CERTIFICATE OF APPROPRIATENESS

Property: 825 Bayland Avenue, Lot 8, Tract 9A, Block 41, Woodland Heights Subdivision. The property includes a historic 2,802 square foot, one-and-a-half-story wood frame single-family residence and a detached garage situated on a 12,543.75 square foot (100.35' x 125') corner lot.

Proposal: Alteration – Addition. The applicant is proposing a small rear addition and the construction of a rear deck. The applicant is also proposing the following alterations to the original structure and previous addition:

EAST SIDE ELEVATION

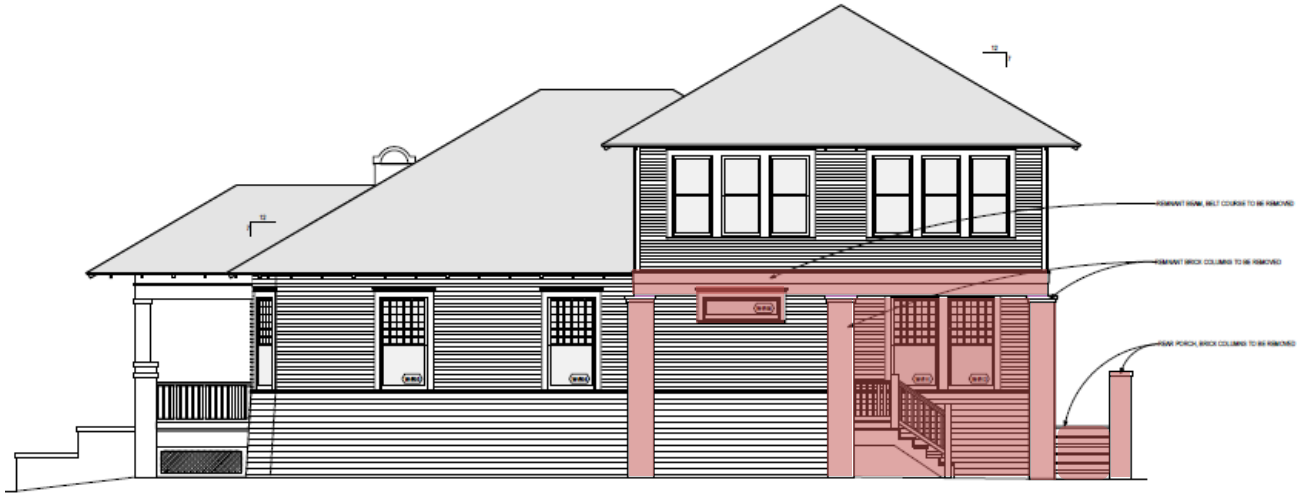
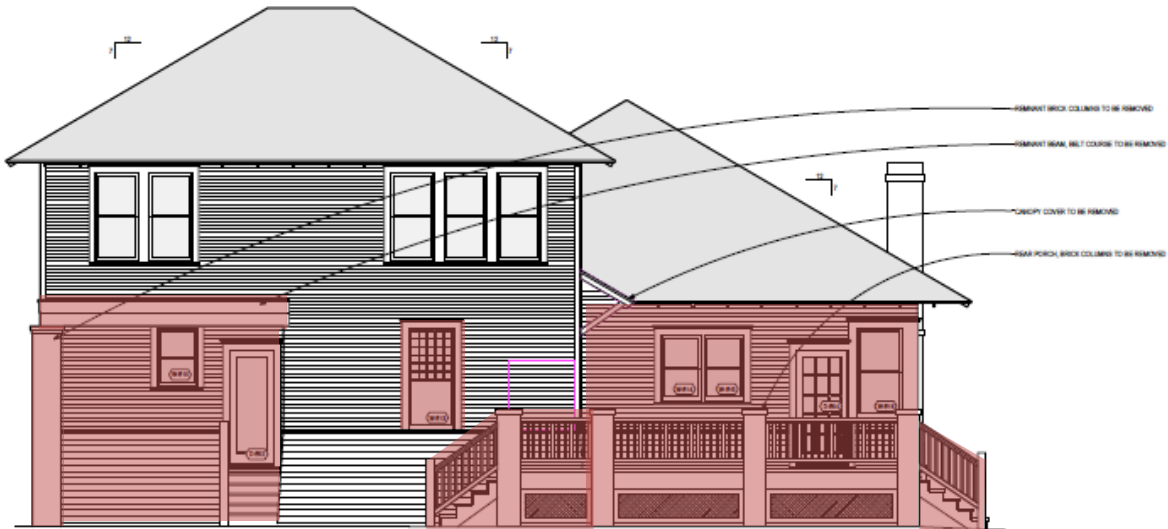
- Remove three remnant brick columns at outside corner and remnant wood beam that was previously added to support a second floor above a porte-cochere on the east elevation.

| <input type="checkbox"/> | <input checked="" type="checkbox"/> | <input type="checkbox"/> | (8) | Proposed additions or alterations must be done in a manner that, if removed in the future, would leave unimpaired the essential form and integrity of the building, structure, object or site; The removal of the brick columns will affect the integrity of the structure | | |
| <input type="checkbox"/> | <input checked="" type="checkbox"/> | <input type="checkbox"/> | (9) | The proposed design for any exterior alterations or addition must not destroy significant historical, architectural, archaeological or cultural material, including but not limited to siding, windows, doors and porch elements; Although the brick columns were not original but they are considered historic and that porte cochere was added very early on. | | |

Recommendation: **Approval with conditions: To retain remnant brick columns at outside corner.**
